TECHNICAL BULLETIN

<p>JAGUAR SERVICE</p>	<p>ZF 4HP 24 E9 Automatic Transmission – Poor Shift Quality in R, 3-4</p> <p>MODEL Sedan (4.0L) Range 1990 - 94 MY DATE 6/95 XJS (4.0L) Range 1993 - 94 MY Up to trans. serial no. 158813</p>	<p>44-27</p>
--	--	---------------------

ILLUSTRATION 1

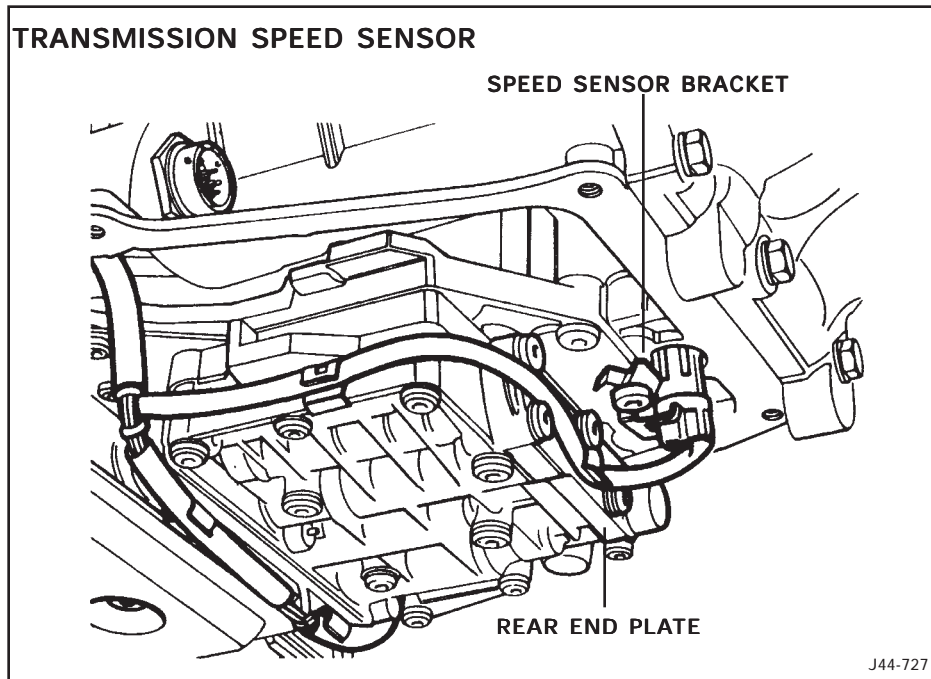
5. Remove the retaining bolts from the speed sensor mounting bracket, Illustration 1, and remove the bracket.

ILLUSTRATION 2

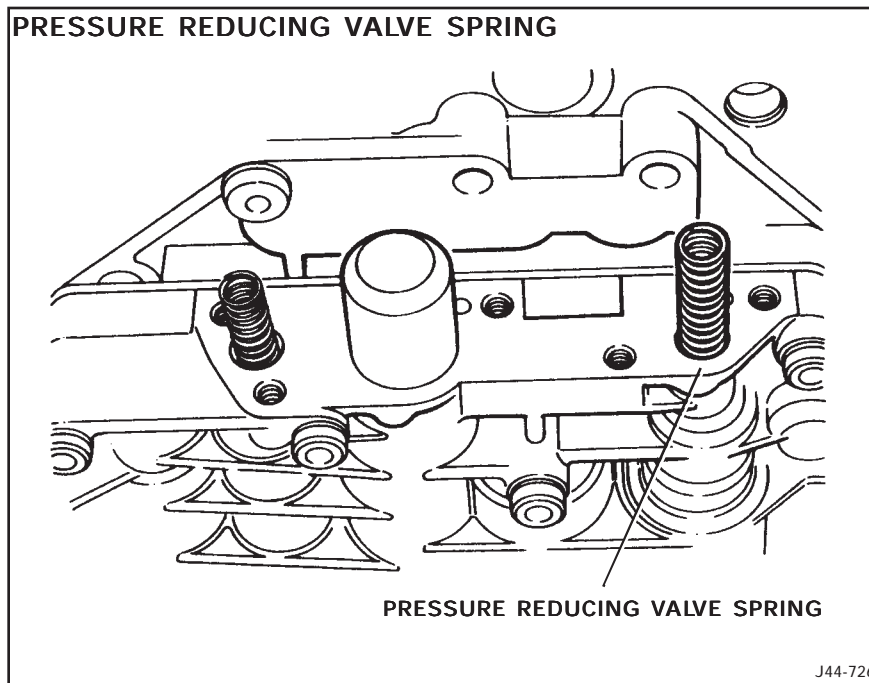
8. Remove and discard the pressure reducing valve spring from the right side location (Illustration 2).
9. Make sure that the pressure reducing valve behind the right side spring moves freely in its bore.

10. Install a new spring, part no. NHD 5601AA, into the bore of the pressure reducing valve.
11. Reinstall the valve body end plate and the clip for the speed sensor harness. Thread, but do not fully tighten, the retaining bolts.
